Groundwater Application Review Summary Form

Application # G- 18877 re-review

GW Reviewer Travis Brown Date Review Completed: 11/22/2022

TO: Water Rights Section Date November 22, 2022
 FROM: Groundwater Section Travis Brown
 Reviewer's Name
 SUBJECT: Application G- 18877 Supersedes review of January 29, 2020
 Date of Review(s)

Hydrographs

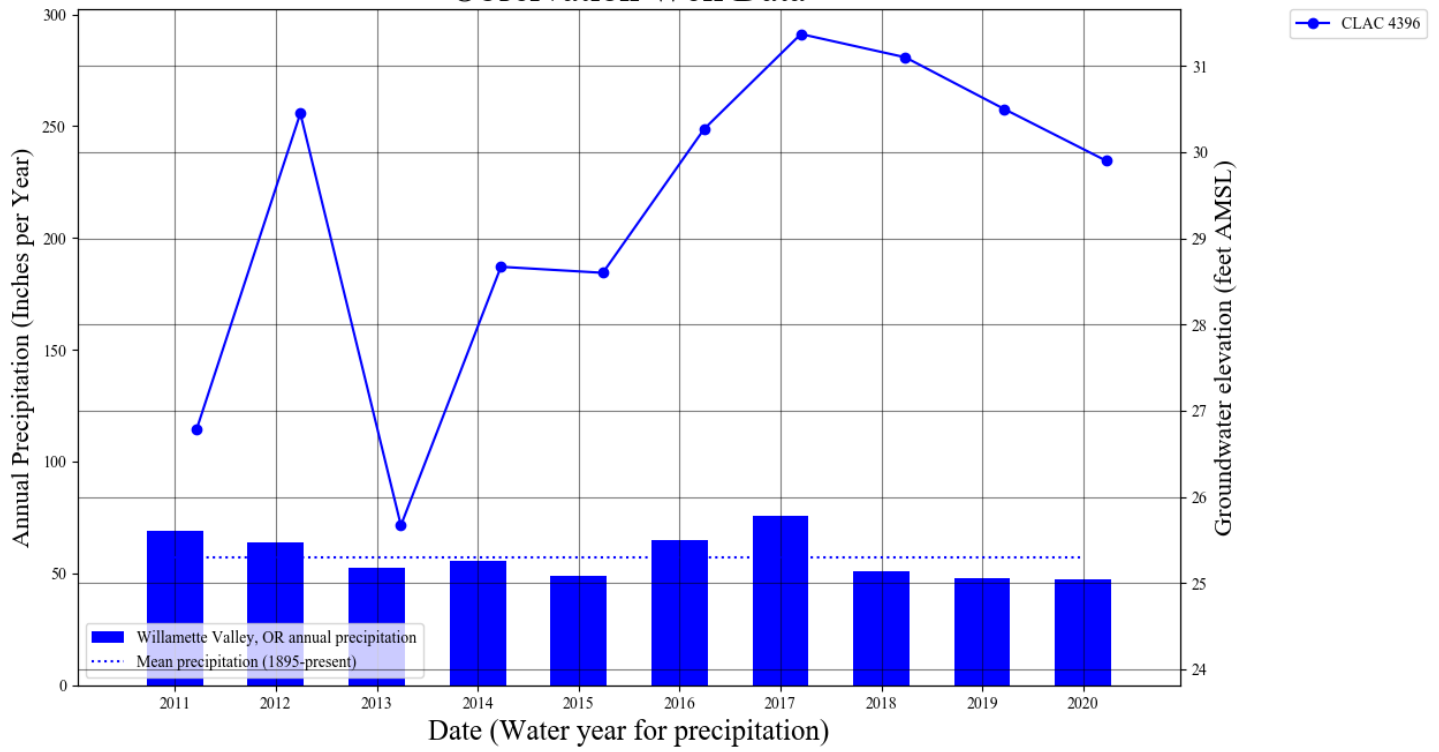
Water level data for the CRBG aquifer(s) in the area of the proposed POA is limited. There is one well with relevant reported water level observations: CLAC 4396, ~1.2 miles west of the proposed POA. A hydrograph of reported water levels from CLAC 4396 does not show persistent declines over the period of record, 2011-2020 (see attached Hydrograph). Reported initial static water levels and well completion depths for wells greater than 350 ft in total depth in the Sections surrounding the proposed POA do not indicate progressive declines in static water levels or deepening well completion depths (see attached Well Statistics).

Well Statistics

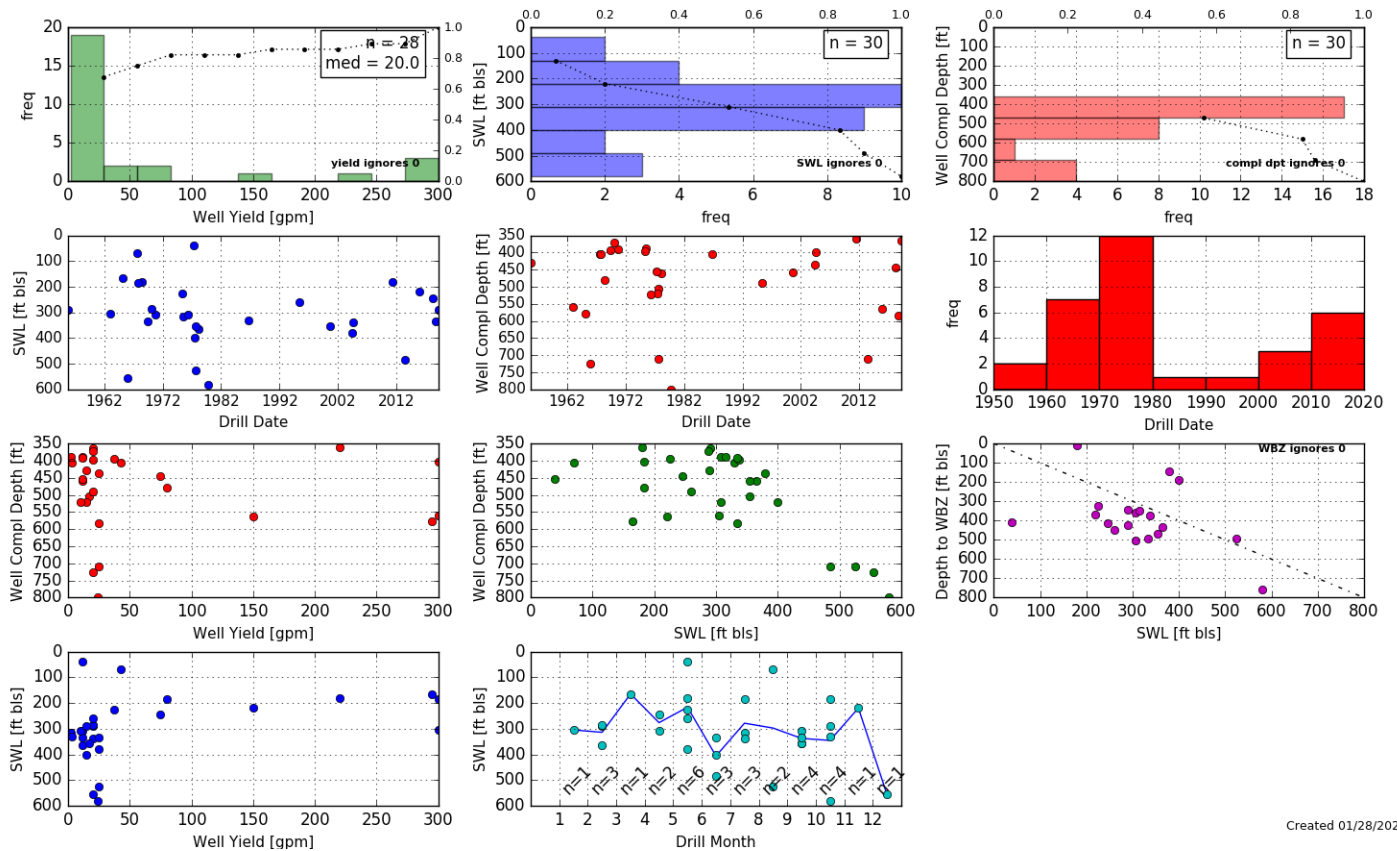
Basis for aquifer confinement evaluation: Static water level reported on the well log for the proposed POA (CLAC 67911) at the time of completion (180 ft bls on 5/16/2011) is above the applicable water-bearing zone in the basalt (~339-361 ft bls), indicating confined conditions. Comparison of reported static water levels to depth to water-bearing zones from well logs deeper than 350 ft in the surrounding Sections similarly indicates confined conditions (see attached Well Statistics).
